UNITED STATES PATENT AND TRADEMARK OFFICE

APPLICATION NO.	FILING DATE	FIRST NAMED INVENTOR	ATTORNEY DOCKET NO.	CONFIRMATION NO.
10/669,273	09/23/2003	Steven J. Fredette	C-3240	6564

Office Action Summary	Application No. 10/669,273	Applicant(s) FREDETTE, STEVEN J. SJE	
	Examiner Melissa Austin	Art Unit 1745

DETAILED ACTION

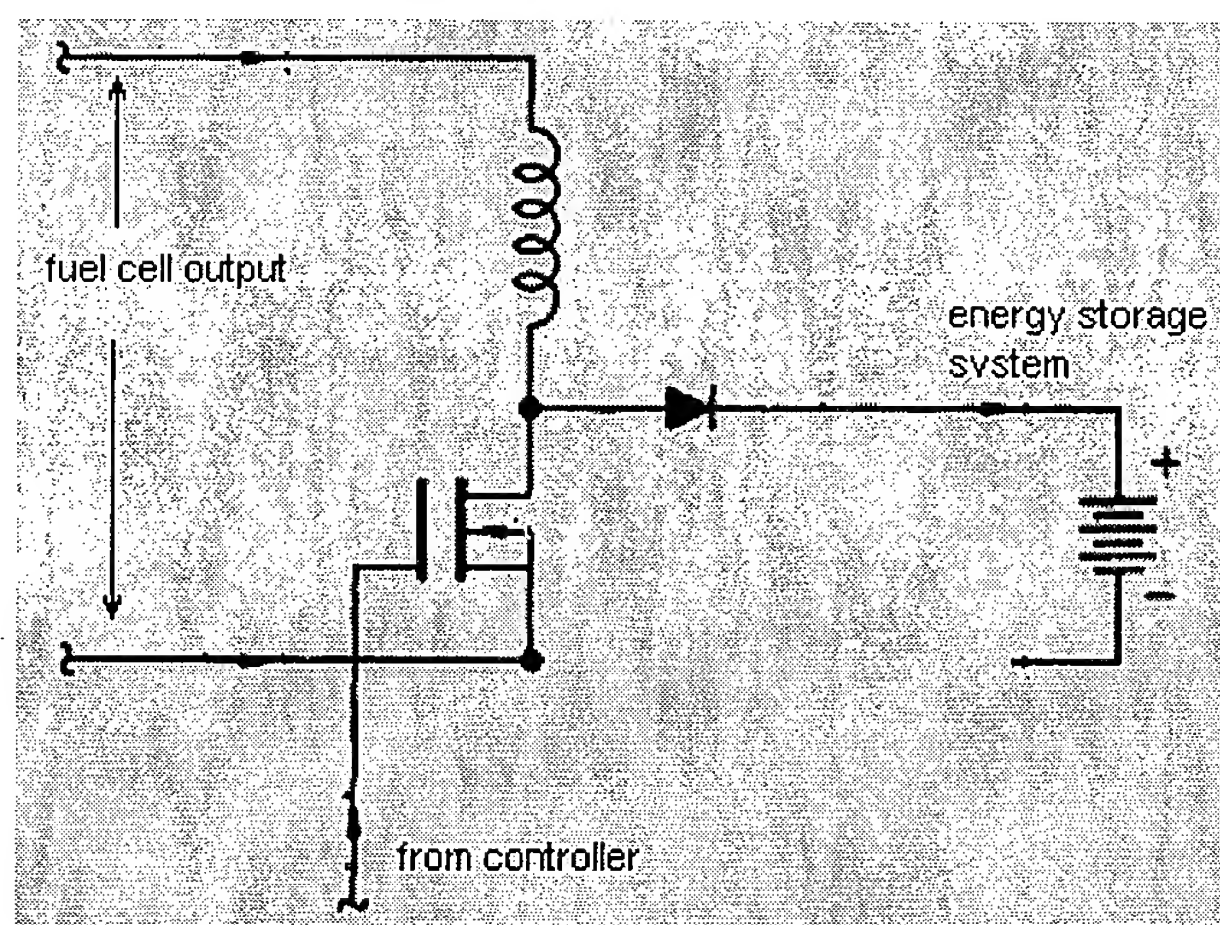
7. Claim 3 is rejected under 35 U.S.C. 112, first paragraph, as failing to comply with the enablement requirement. The claim(s) contains subject matter which was not described in the specification in such a way as to enable one skilled in the art to which it pertains, or with which it is most nearly connected, to make and/or use the invention. The reading of claim 3 results in the following circuit schematic:

Applicant's specification does not enable one of ordinary skill in the art to make or use the invention of instant claim 3. The specification is enabling for the invention of instant claim 2, where the circuit is the same as the schematic above except that the negative terminal of the energy storage system and the lower fuel cell output are connected. The specification includes no description of the embodiment of instant claim 3 or how it may be made or used for storage of energy from a fuel cell. This rejection may not be overcome by amending the specification to include the embodiment of instant claim 3 because the instant claim is not an original claim, and, as such, would constitute new matter in the specification.
